To: T10 Technical Committee  
From: Barry Olawsky, HP ([barry.olawsky@hp.com](mailto:barry.olawsky@hp.com)) and  
Rob Elliott, HP ([elliott@hp.com](mailto:elliott@hp.com))  
Date: 26 January 2004  
Subject: T10/04-337r3 SAS-1.1 TCTF Editorial Changes

### 5.3.11 Transmitter characteristics

**Figure 51 — Compliance interconnect-TCTF test load**

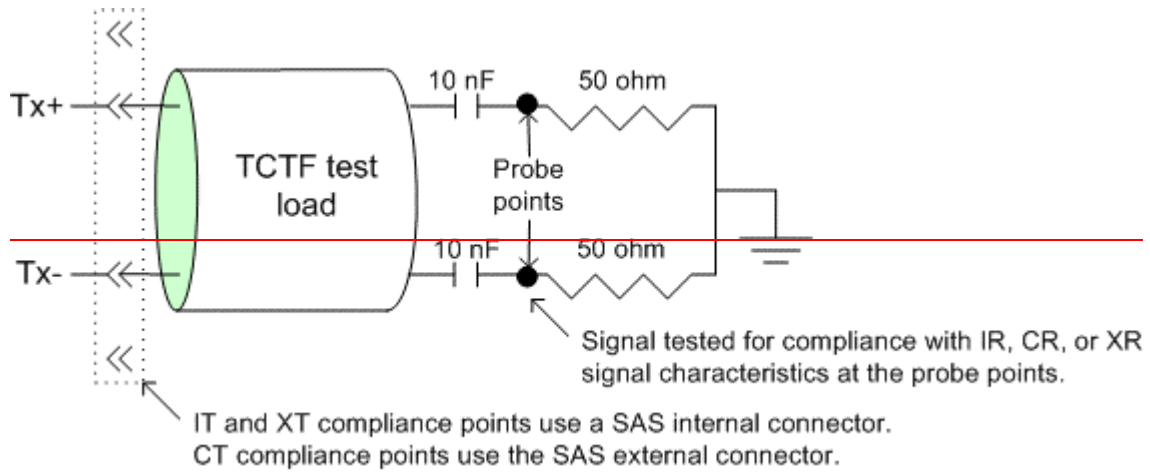
Compliance with the TCTF test load requirement shall be determined by measuring the signal produced by the transmitter through a physical ~~compliance interconnect~~ TCTF test load attached to the transmitter compliance point (i.e., IT, CT, or XT) as shown in figure 51.

Figure 51 shows the ~~compliance interconnect~~ TCTF test load. Physical positions are denoted as 'probe points' in several of the figures 51 and 52 in this clause. Probe points identify the position in the testing procedures where the signal properties are measured but do not imply that physical probing is used for the measurement. Physical probing may be disruptive to the signals and should not be used unless verified to be non-disruptive.

**Figure 52 — Zero-length test load**

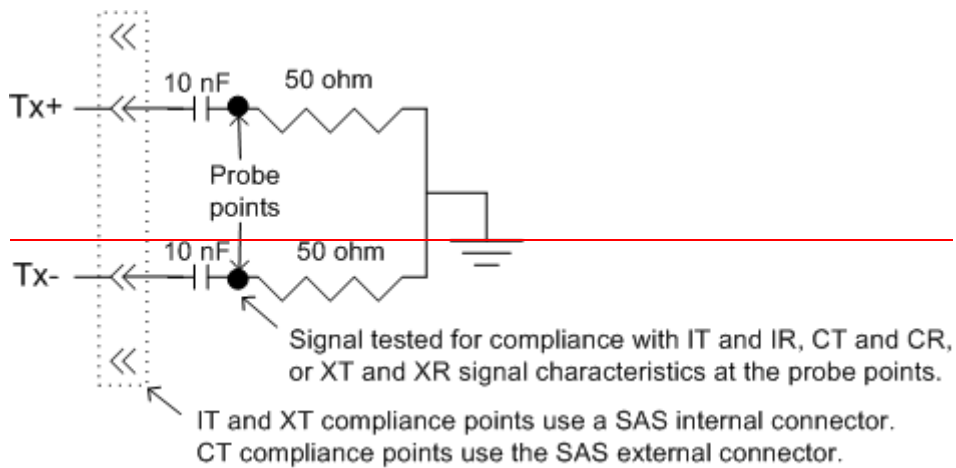
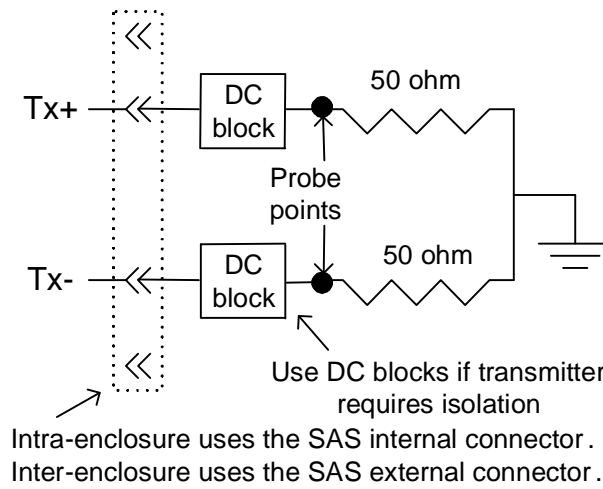
Compliance with the zero-length test load requirement shall be determined by ~~measurement made across measuring the signal produced by the transmitter through~~ a load equivalent to the zero-length load attached to the transmitter compliance point (i.e., IT, CT, or XT) as shown in figure 52.

Figure 52 shows the zero-length test load.

Figure 53 — ISI loss example TCTF  $S_{21}$  and ISI loss requirements at 3,0 Gbps

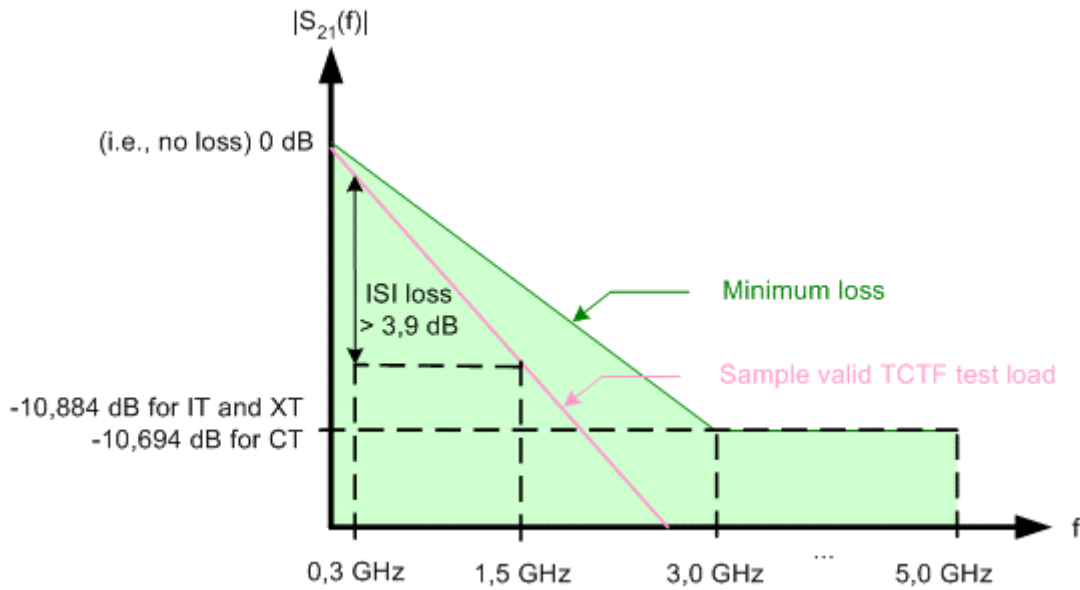
Figure 53 shows an ISI loss example the allowable  $|S_{21}(f)|$  and minimum ISI loss of a TCTF test load and the  $|S_{21}(f)|$  of a sample TCTF test load at 3,0 Gbps.

[Note to editor – Generate separate graphs for IT/XT and CT since the CT line is not straight.]

Figure 54 — ISI loss example TCTF  $S_{21}$  and ISI loss requirements at 1,5 Gbps

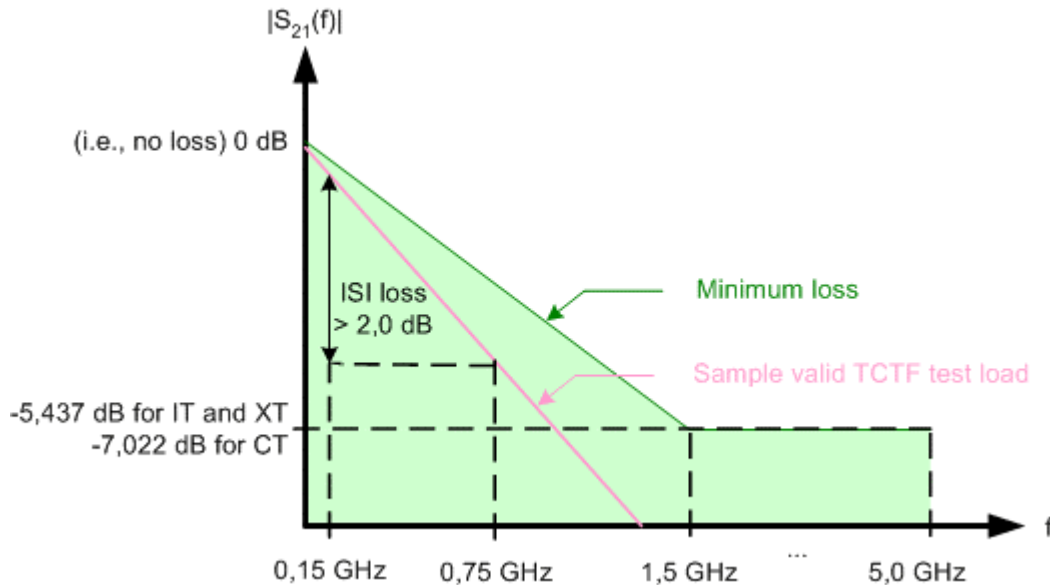
Figure 54 shows an ISI loss example the allowable  $|S_{21}(f)|$  and minimum ISI loss of a TCTF test load and the  $|S_{21}(f)|$  of a sample TCTF test load at 1,5 Gbps.
